CALIFORNIA COASTAL COMMISSION

**STAFF REPORT: REGULAR CALENDAR**

APPLICATION NUMBER: 5-01-018

PROJECT LOCATION: 501 Paseo de la Playa, City of Torrance, Los Angeles Co.

EXHIBIT # 3
 PAGE 1 OF 6

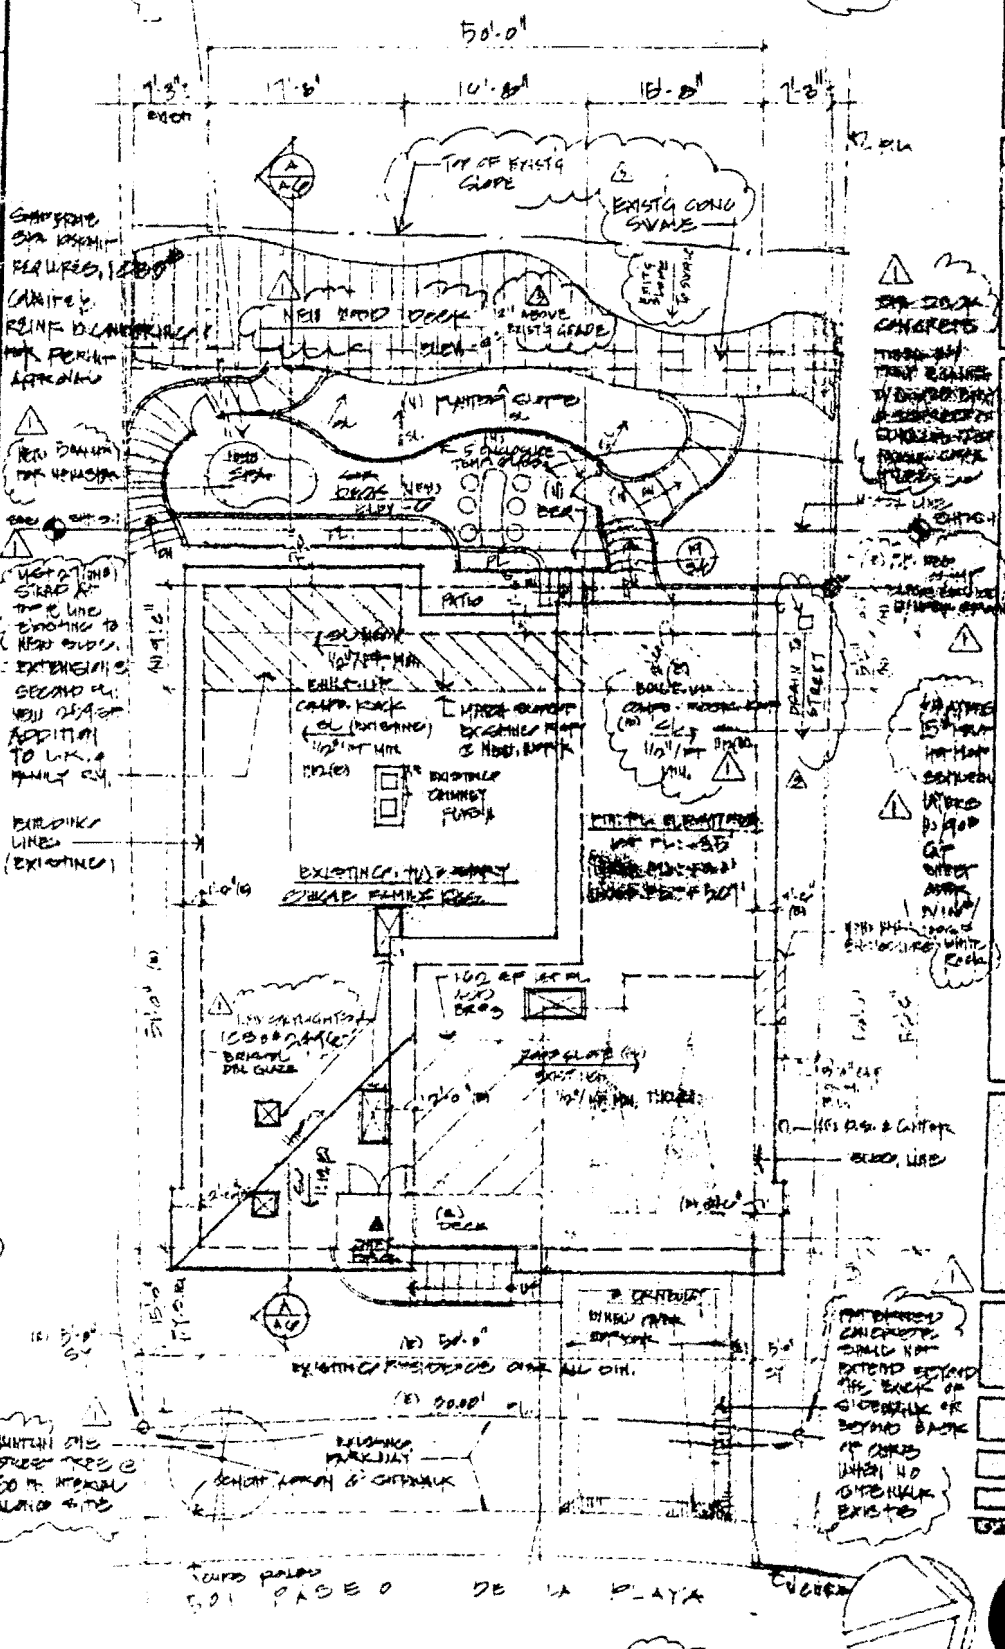
Seaward of the concrete swale is a relatively flat grade that extends approximately seven horizontal feet (Exhibit #3, p.2). At the edge of the bench the bluff descends to the sandy beach. The applicants assert that the edge of the bench is the top of the bluff. The applicants point out that the seaward edge of the bench is identified on a site plan for a number of houses dated 1961 as the "irregular top of cliff" (Exhibit #5). The 1961 plan also shows the footprints of the existing blufftop homes. The slope below the cut slope extends approximately 300 linear feet down to the beach where the property has a maximum width of 86 feet at the seaward property line.

1. Show only development inland of the top of bluff on the plans and eliminate from plans all proposed development seaward of the top of the bluff.
2. Show the proposed living room and family room addition inland of the top of bluff at the rear of the existing single family residence.
3. Relocate inland of the top of bluff or eliminate from plans the proposed patio area, spa, retaining walls, stairs and cantilevered wood deck.
4. Eliminate the previously revised plans, which incorporated Revision 3, Drainage Plan, for the proposed spa.
